**SUBJECT:** Peach Bottom Atomic Power Station, Units 2 and 3  
Response to Request for Additional Information Regarding Review of  
Individual Plant Examination of External Events

Response to Request for Additional Information  
Peach Bottom Atomic Power Station, Units 2 and 3  
Individual Plant Examination of External Events (IPEEE)

Figure S.2-1

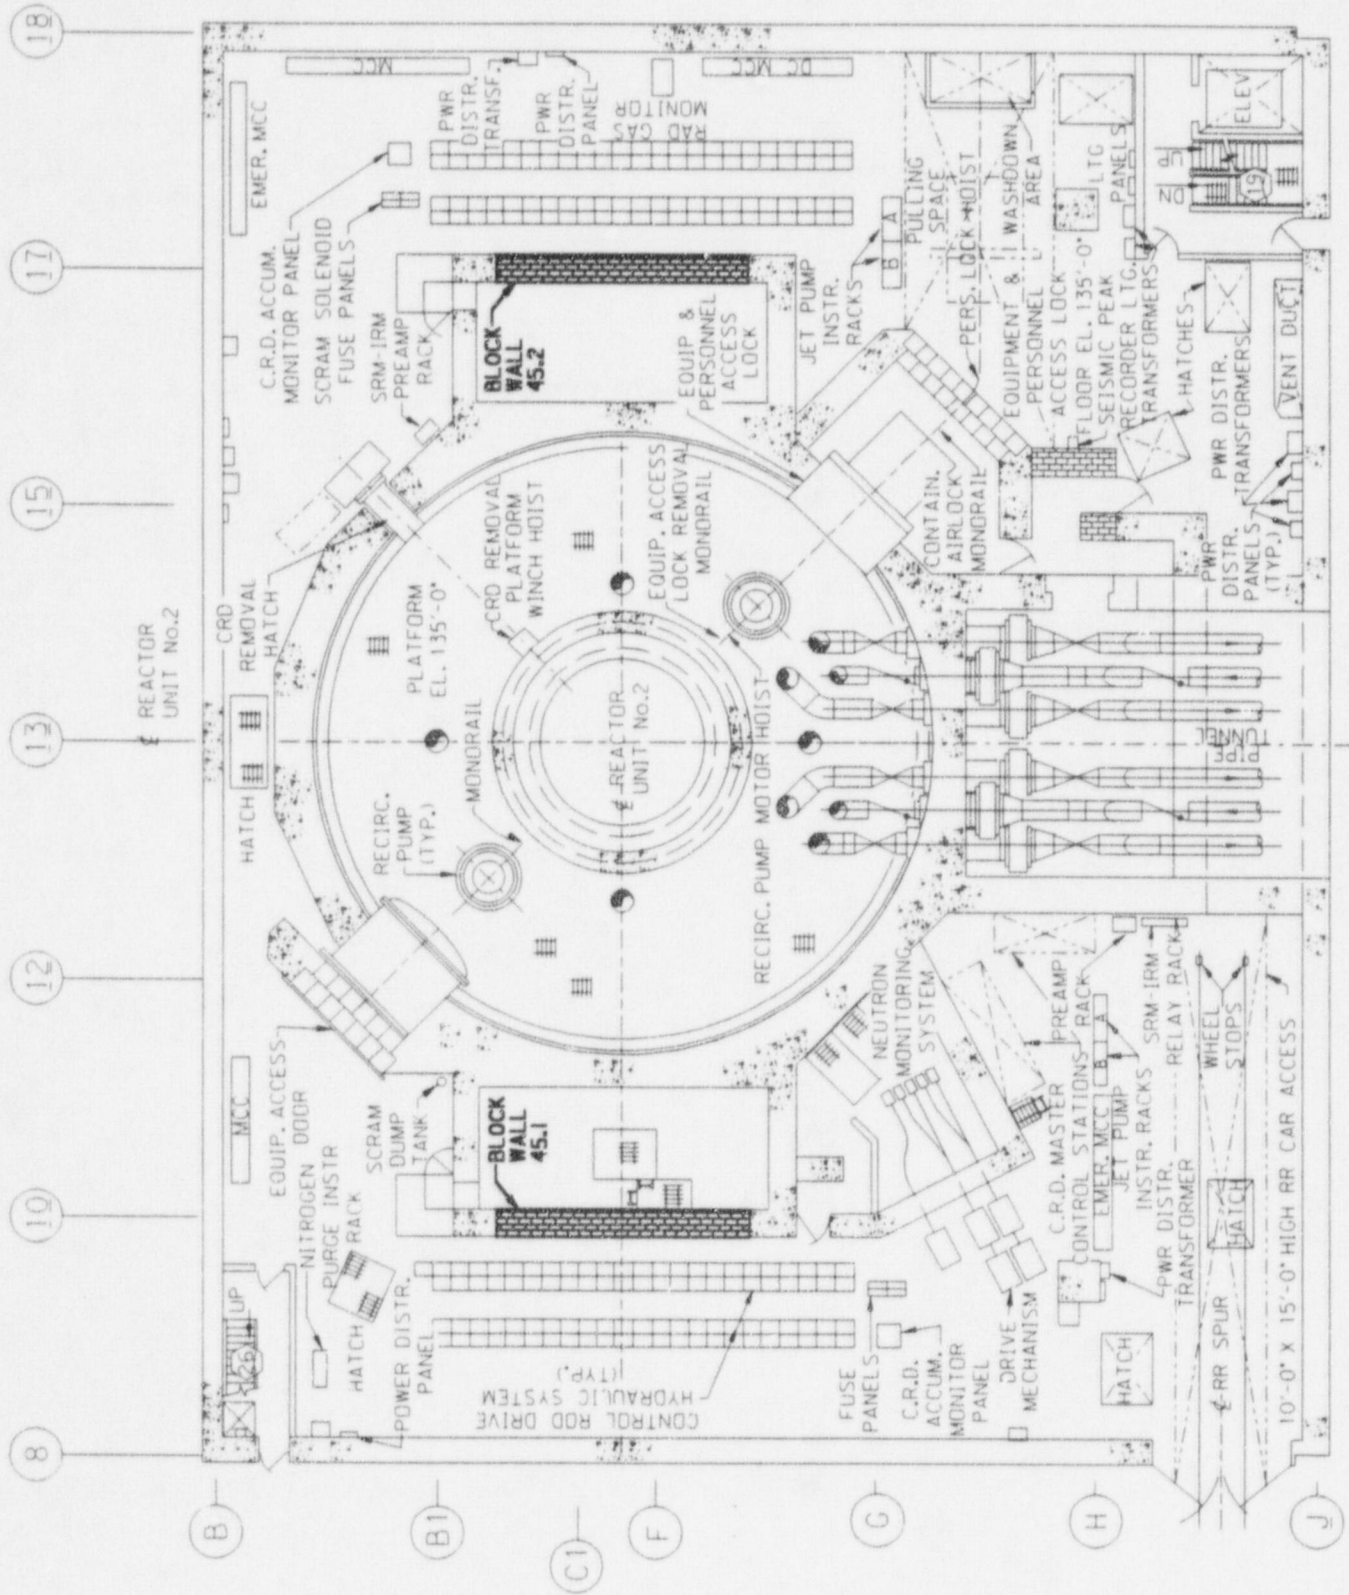
2. The submittal has not presented a list of the masonry/block walls whose failure could interact with: success path component list (SPCL) components; components needed to maintain early containment integrity; components whose failure could induce a fire, flood, or release of harmful chemicals; or components needed for fire suppression. The submittal references calculations that demonstrate block wall seismic design adequacy, but does not describe the approach and results of such calculations. Furthermore, Supplement No. 5 of Generic Letter 88-20 requests that seismic margins assessment evaluations of block walls affecting safety equipment be performed for focused-scope plants at the RLE value of 0.3g, rather than at the safe-shutdown earthquake (SSE). Please provide a list of masonry block walls potentially affecting safety equipment, report their HCLPF capacities, and submit capacity calculations for a bounding (lowest capacity) case.

2. The masonry block walls that are in the vicinity of safety related equipment were reviewed using drawings and design calculations to determine the critical walls to be analyzed. The critical walls were analyzed using the methods outlined in Appendix R of EPRI NP-6041, "A Methodology for Assessment of Nuclear Power Plant Seismic Margin." The critical walls selected and their HCLPF capacities are listed below:

<u>Wall</u>	<u>Location</u>	<u>HCLPF</u>
40.2	Turbine Building Elev. 135'-0"	0.47g
68.4	Turbine Building Elev. 150'-0"	0.37g
412.1	Reactor Building Elev. 180'-0"	0.48g
406.2	Reactor Building Elev. 135'-0"	0.20g

Wall 406.2 is representative for wall 406.1 in Unit 3 and walls 45.1 and 45.2 in Unit 2; therefore, all four of these walls have the same HCLPF. The location of these four walls are shown in attached Figures S.2-1 and 2.
